HISTORIC AND DESIGN REVIEW COMMISSION

HDRC CASE NO: 2022-391
ADDRESS: 1903 N IH 35
LEGAL DESCRIPTION: NCB 1277 BLK 6 LOT 13
ZONING: RM-5, H
CITY COUNCIL DIST.: 2
HIST. DIST. NAME: Government Hill
APPLICANT: Gabriel Leyva / 1903 N IH 35
OWNER: Gabriel Leyva / 1903 N IH 35
TYPE OF WORK: Front-yard fence installation
APPLICATION RECEIVED: July 16, 2022
60-DAY REVIEW: Not applicable due to City Council Emergency Orders
CASE MANAGER: Jessica Anderson

The applicant requests a Certificate of Appropriateness for approval to construct a metal post and rail cattle panel fence in the front and side yard.

proposed fence in RED

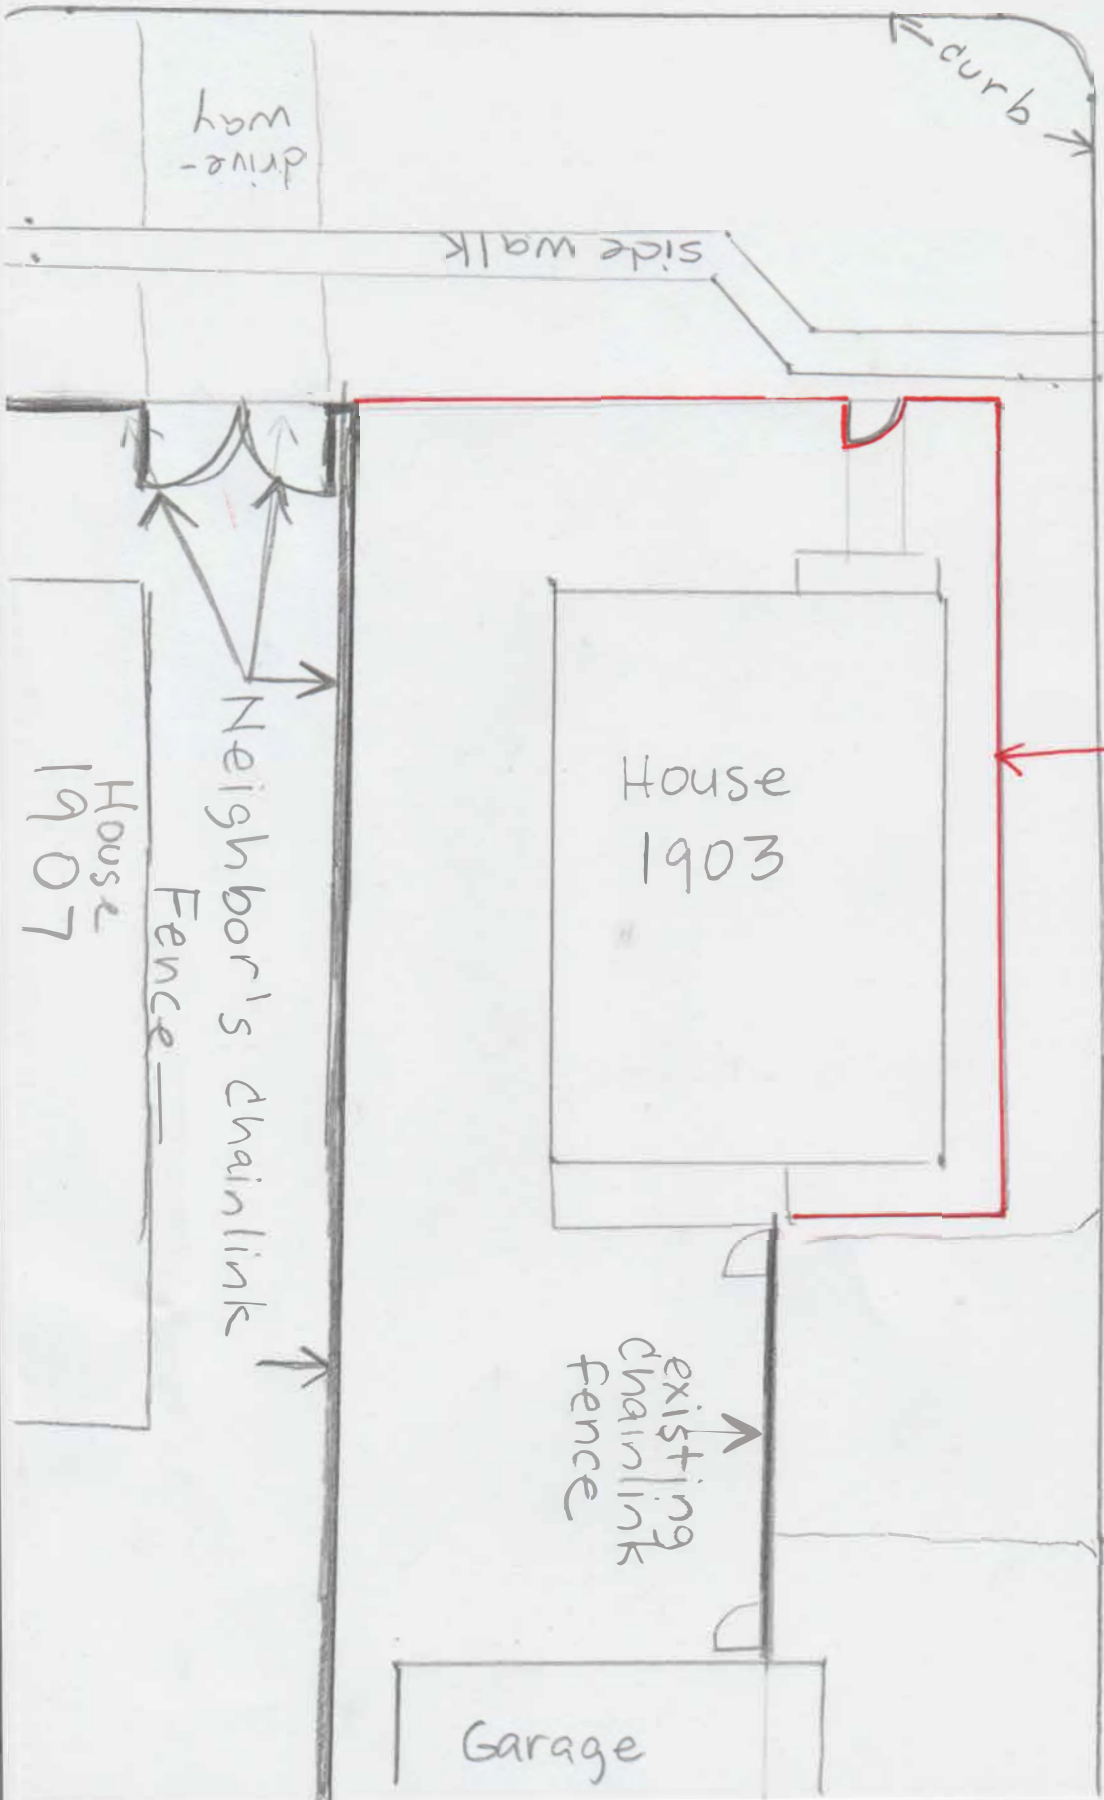
- b. FENCE: The applicant proposes to install a cattle panel fence with metal posts and rails along the south and west edges of the parcel to meet an existing chain link fence at the northwest corner of the rear porch. A gate is proposed on the south side of the fence where the front walkway meets the fence. Staff finds this proposal generally conforms to guidelines.

- c. MATERIALS: The applicant proposes to install a cattle panel fence with metal posts and rails. Guidelines for Site Elements 2.B.i states that new fences and walls should appear similar to those used historically within the district in terms of their scale, transparency, and character. Metal-framed cattle panel fences are not an historic conditions, and staff finds the proposed materials do not conform to guidelines. Staff finds a cattle panel fence with wood posts and rails to be more appropriate.

- d. HEIGHT: The applicant did not indicate the height of the proposed fence. Guideline for Site Elements 2.B.iii states that the height of new fences and walls within the front yard should be limited to a maximum of four feet.

- i. That the applicant use wood posts and rails.
- ii. That the fence not exceed four feet in height.
